R44 SERVICE BULLETIN SB-112C

SUBJECT: Tail Rotor Blade Inspection and Replacement

EFFECTIVITY: P/N C029-3 tail rotor blade S/Ns 14329 and prior (C029-3 REV Q and prior). Affected blades were factory-installed on the following aircraft:

SPECIAL TAIL ROTOR TIP PREFLIGHT INSPECTION

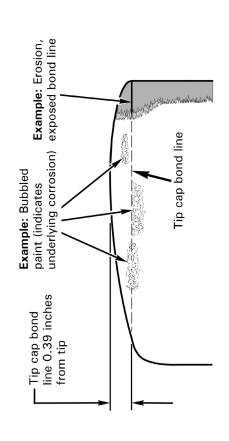
Refer to Figure below.

To be performed before the first flight of each day. May be tail rotor tip area. If bubbled paint or other evidence of corrosion is observed at or adjacent to tip cap bond line or if any portion Conduct visual inspection of of tip cap bond line is exposed, do not fly helicopter. Comply with latest revision of R44 SL-82 prior to further flight. performed by pilot or mechanic.
